STAFF RECOMMENDATION
1502 Cedar Lane
December 18, 2019

Application: New Construction—Addition; Partial Demolition
District: Belmont-Hillsboro Neighborhood Conservation Zoning Overlay
Council District: 18
Base Zoning: R8
Map and Parcel Number: 11704030400
Applicant: Matthew McCrary, Allard Ward Architects
Project Lead: Melissa Baldock, melissa.baldock@nashville.gov

Description of Project: The applicant proposes to construct a rear addition that is wider than the historic house. The application also involves removing an existing rear addition, side patio, and columns, and altering window and door openings, which is considered partial demolition.

Roof Plan

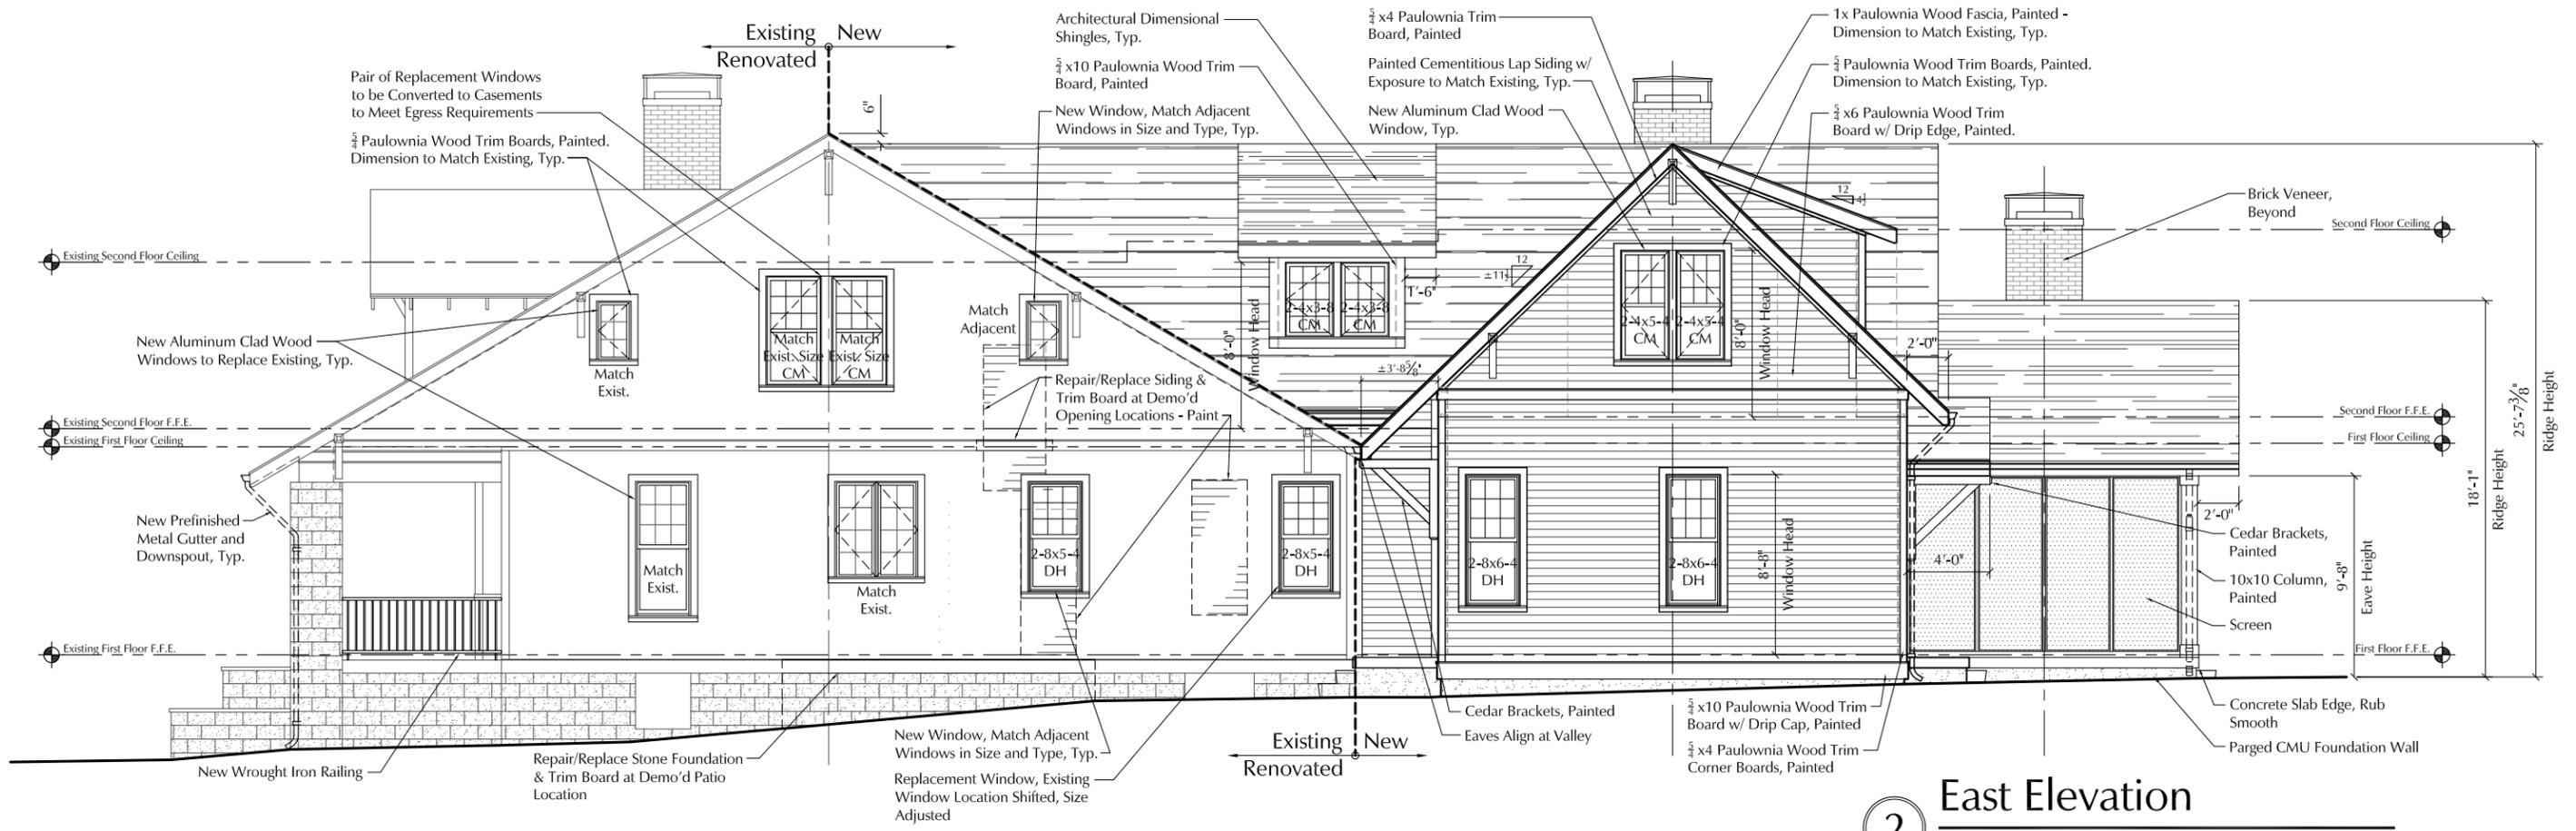
Roof form: The addition’s primary roof form are a side gable with a 11/12 pitch and a rear-facing gable with a 9/12 pitch. The shed roof dormers are adequately inset a minimum of two feet (2’) from the historic house’s side walls. These roof forms and slopes meet the design guidelines.

Staff finds that the proposed roof forms meet Section II.B.1.e. and II.B.2. of the design guidelines.

1 Cedar Lane Elevation
 Scale: 1/8"=1'-0"

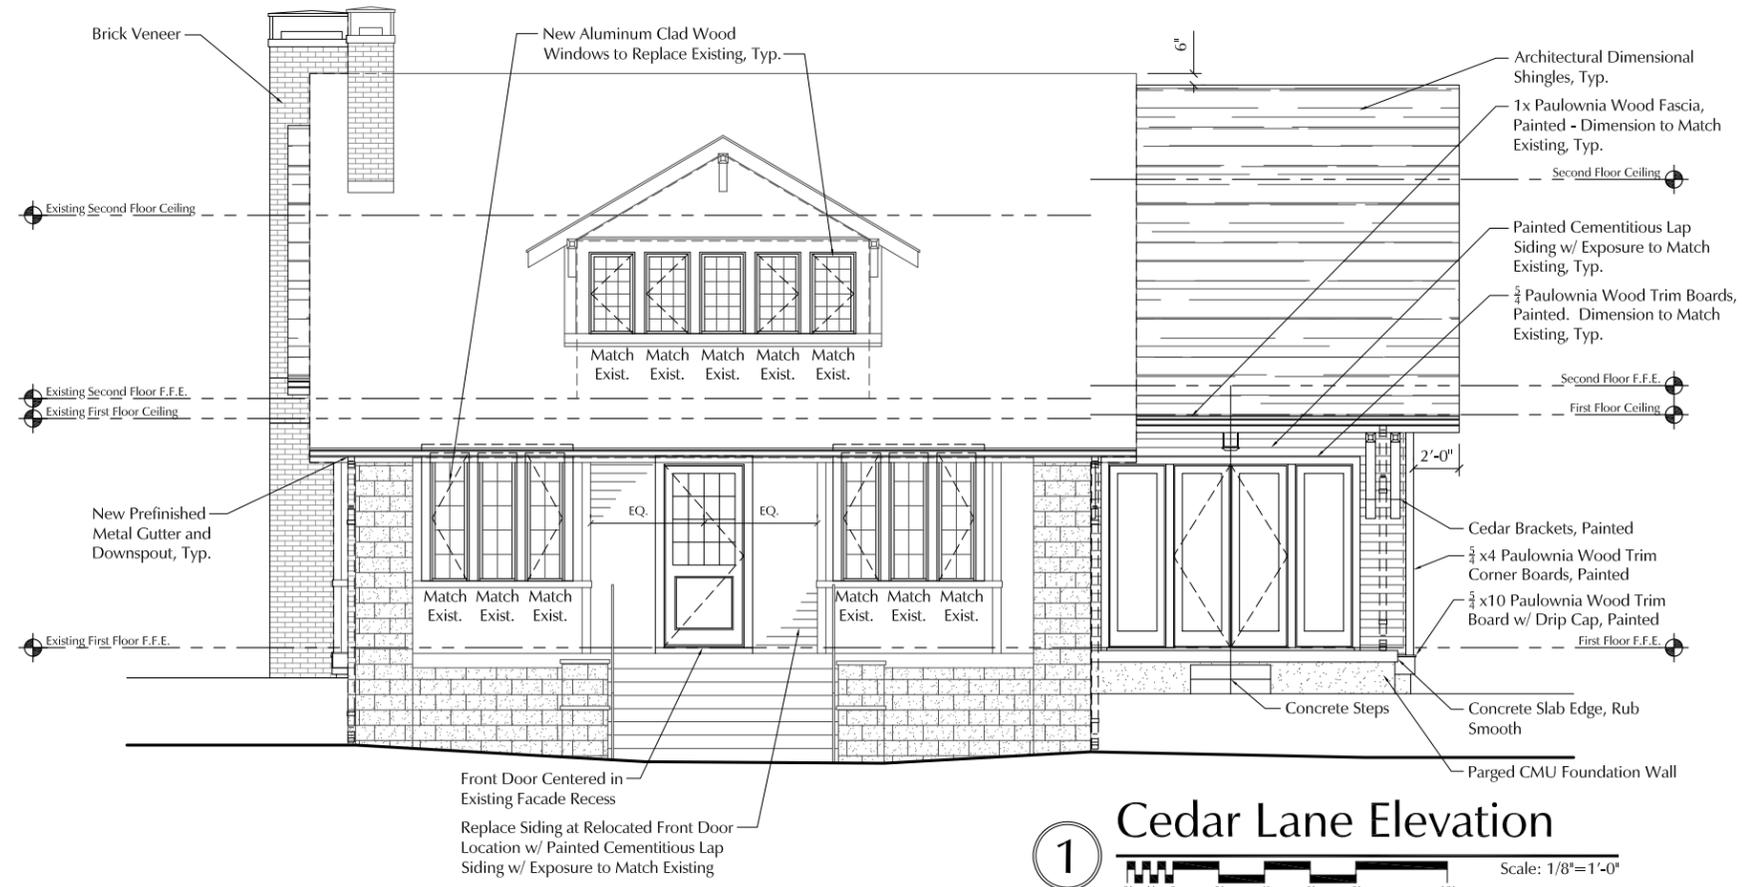
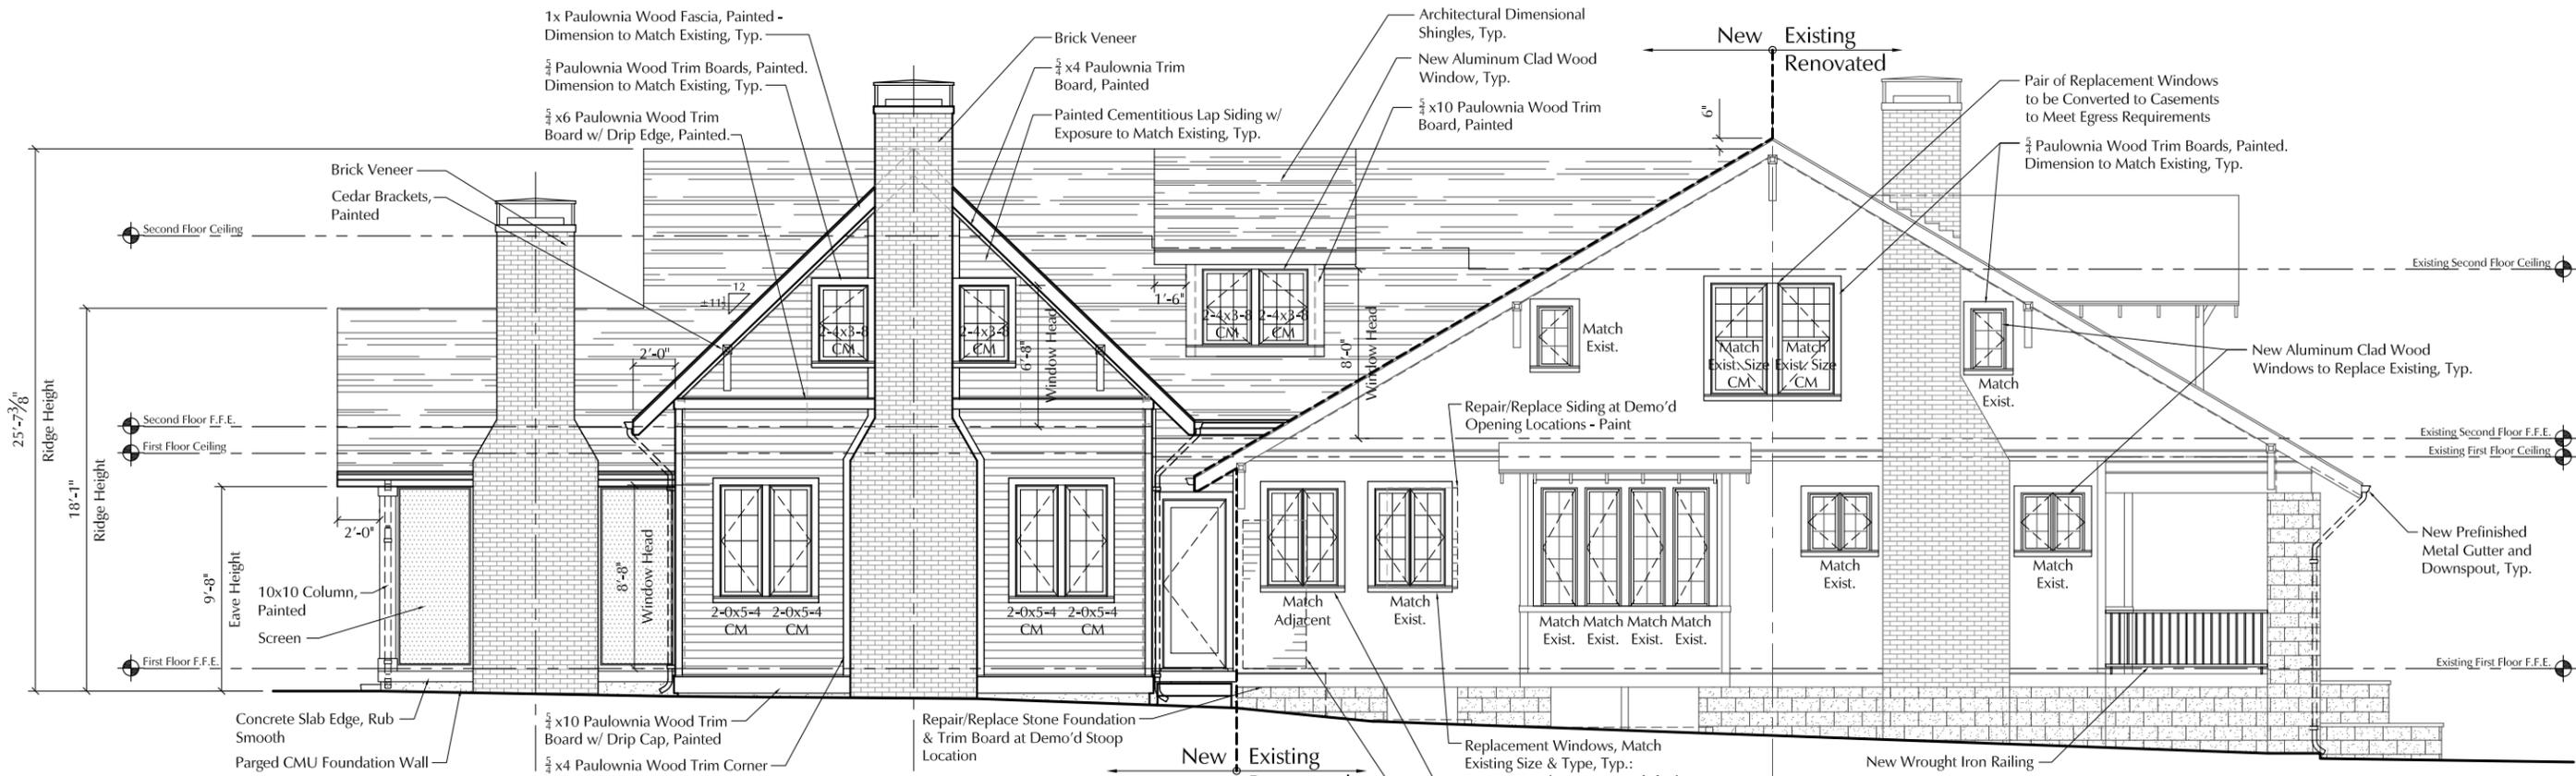
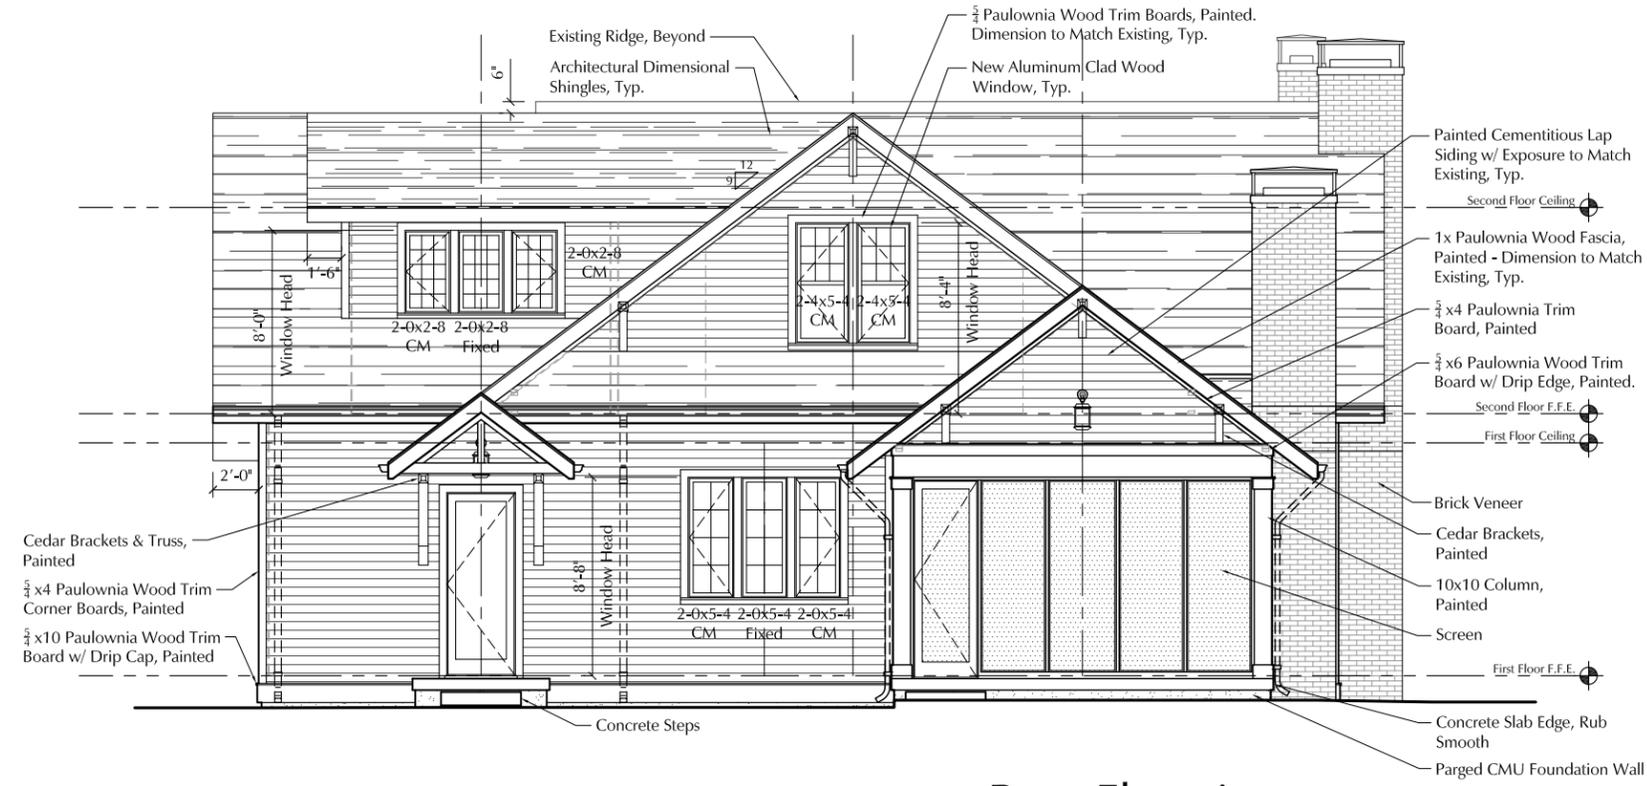
Height & Scale: The addition will be one and a half stories in scale and will be six inches shorter than the historic house, which staff finds to be appropriate. The addition is inset one foot by four feet (1' X 4') at the back corners of the house, which staff finds to be appropriate. On the left side, after the inset, the addition steps back out to line up with the side bay, which is appropriate. On the right side, after the inset, the addition steps back out to be fourteen feet (14') wider than the historic house. Staff finds this wider portion to be appropriate because the lot is unusually wide at over seventy-three feet (73'). The wider portion of the addition is no taller than the historic house and its width is less than one-half the width of the historic house. It also has a side-gable form.

Staff finds that the addition's height and scale meet Sections II.B.1.a., II.B.1.b., and II.B.2. of the design guidelines.
